**ENGINEERING GEOLOGY AND
GEOTECHNICAL ENGINEERING REPORT**

FOR PROPOSED REMODELING OF
LOCKER ROOM AND KITCHEN AT
MATILIJIA JUNIOR HIGH SCHOOL,
703 EL PASEO ROAD,
OJAI, CALIFORNIA

PROJECT NO.: 302294-001

Engineering Geology and Geotechnical Engineering Report for Proposed Remodeling of Locker Room and Kitchen at Matilija Junior High School, 703 El Paseo Road, Ojai, California: Earth Systems Pacific, 1731-A Walter Street, Ventura, California 93003; company Project No. 302294-001, report dated July 12, 2018, 20 pages, 4 appendices.

SITE PLAN		
Matilija Jr. High School		
Locker Room And Kitchen Remodels		
Ojai, California		
 Earth Systems		
July 2018	302294-001

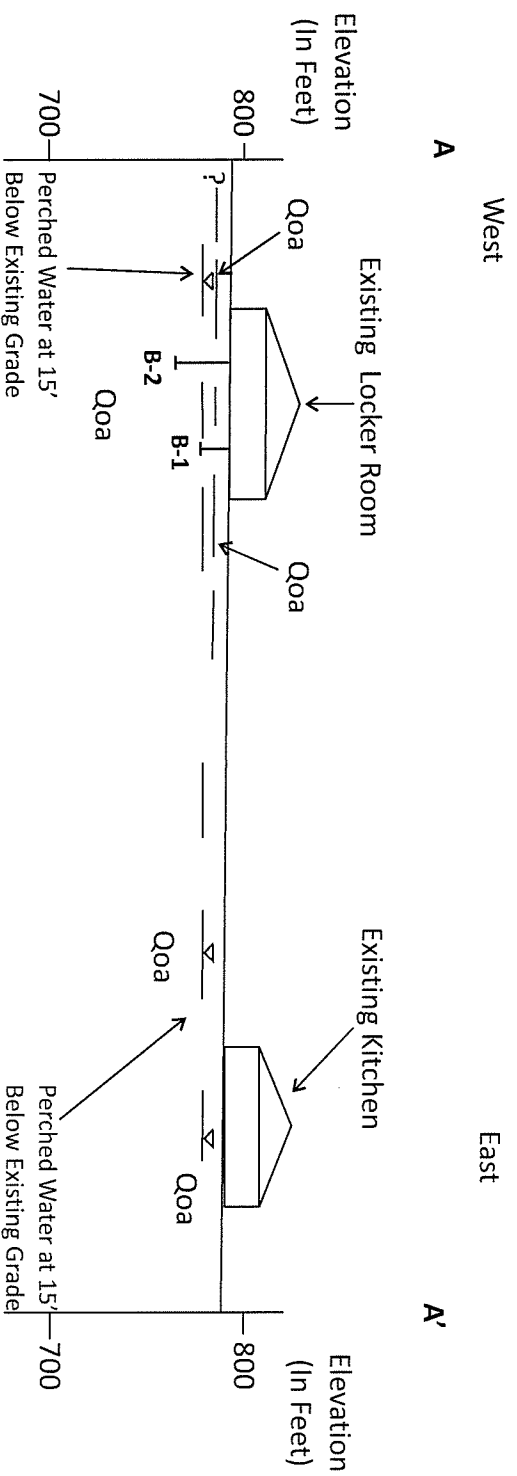
1. Site Location Map, Street Address, County Name: Adequately addressed.
2. Plot Plan with Exploration Data with Building Footprint: Adequately addressed.
3. Site Coordinates: Adequately addressed. Latitude and Longitude provided in report:
34.4453°N, 119.2552°W
